**Osewalt Setback Modification  
File Number: 11-110690-LO**

May 19, 2011  
Project No. KE110161A

Subject: Response to City of Bellevue Questions for Osewalt Property  
3720 163<sup>rd</sup> Avenue SE  
Bellevue, Washington

**SITE PLAN**  
SCALE: 1" = 10'-0"

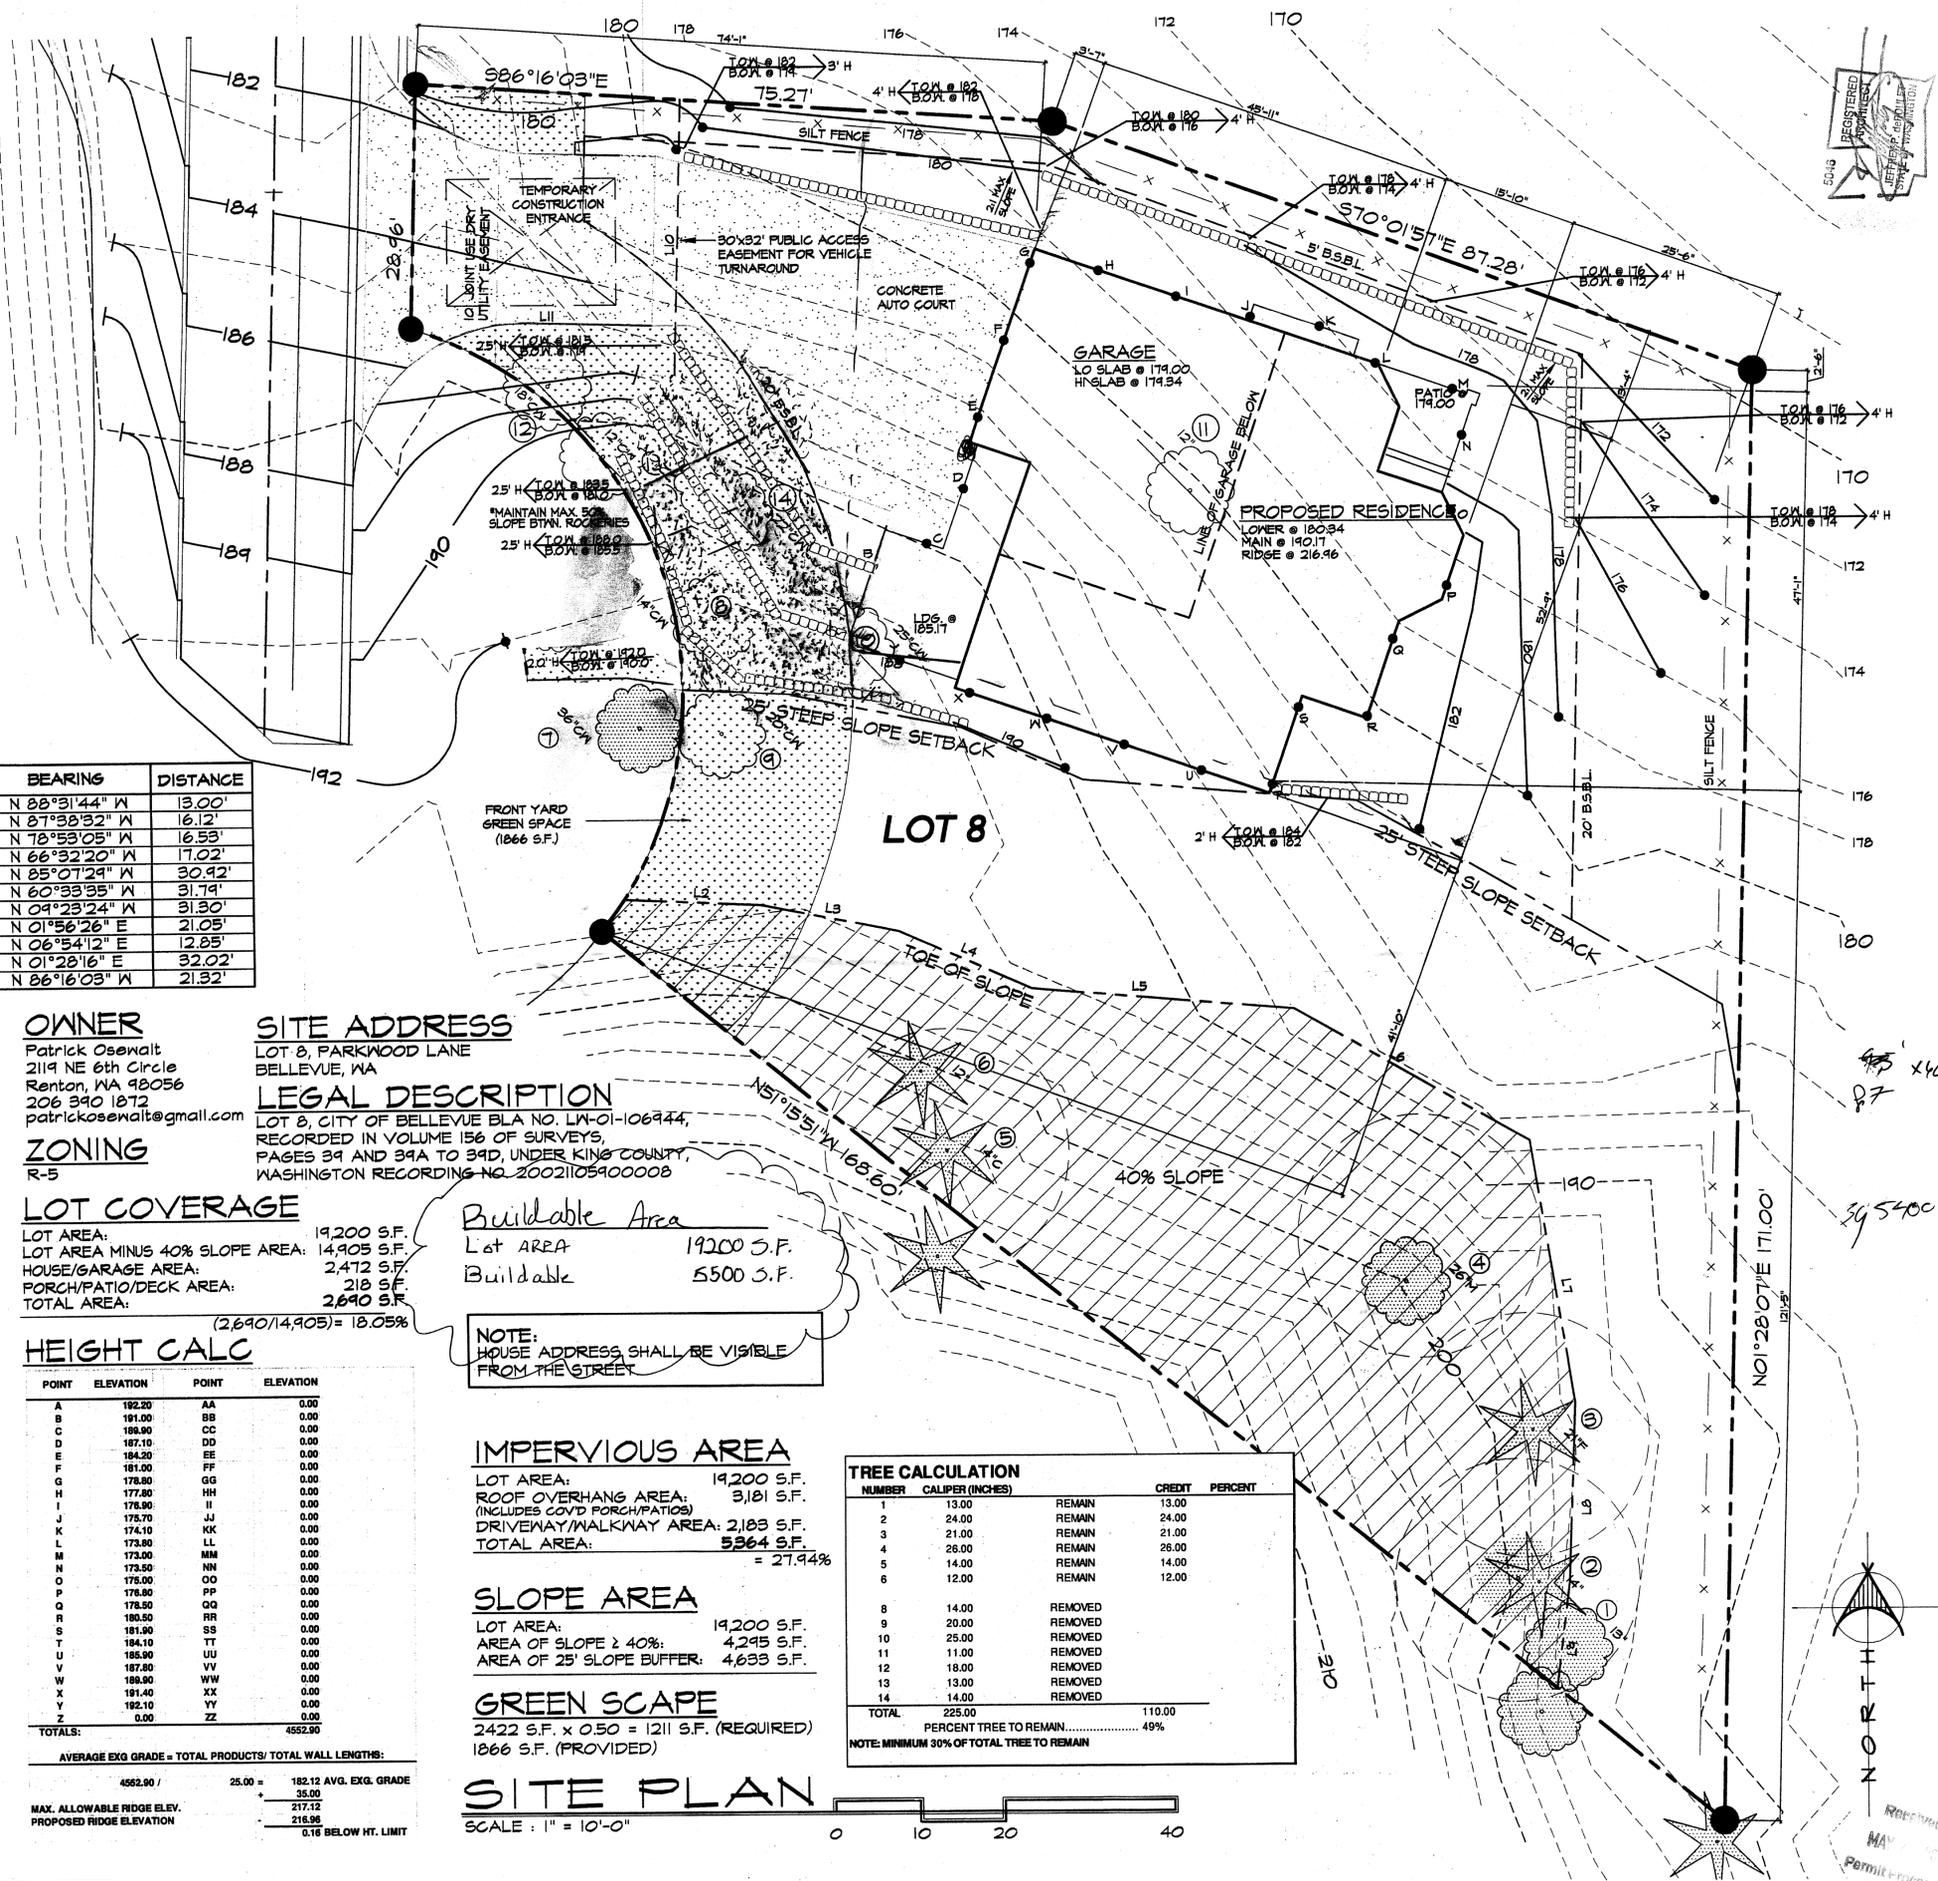
*D. The use of retaining walls that allow the maintenance of existing natural slope area is preferred over graded artificial slopes where graded slopes would result in increased disturbance as compared to use of retaining wall;*

*F. Where change in grade outside the building footprint is necessary, the site retention system should be stepped and regrading should be designed to minimize topographic modification. On slopes in excess of 40 percent, grading for yard area may be disallowed where inconsistent with this criteria;*

*Please show on the plans that there is at least 2,160 square feet of buildable area once the landslide hazard evaluation is completed.*

Response: The plans show a cut of up to 9 feet for the proposed driveway, but limit the cut as much as is practical through the use of tiered walls, rockeries, and sloped excavations. The rockeries step up the slope to limit alteration of natural soil slope conditions. Slopes between the rockeries will be constructed to no greater than 2:1 H:V (Horizontal:Vertical). A 9-foot cut will also be required for a portion of the building foundation. This portion of the slope will be supported by the foundation wall. On the northern side of the house a retaining wall is planned. This wall will be approximately 4 feet high and will not significantly alter the natural slope conditions. (See page A0 of plan set)

Response: The plans show the use of tiered rockeries with heights of 30 inches or less stepping up the slope, with slopes between the rockeries of no more than 2H:1V, to mitigate modification of the slope conditions. The recommended cross-section detail for these tiered rockeries is attached to this comment response letter. On the northern side of the house a retaining wall is planned. This wall will to be approximately 4 feet high and will not significantly alter the natural slope conditions. No slope modifications are planned on the marked steep slope area or within the 25-foot buffer zone.

Response: Steep slope areas are mapped, along with the approved 25-foot toe of slope setback, on the drawing on page A0 of the plans. The calculation of buildable square footage is to be determined by others.
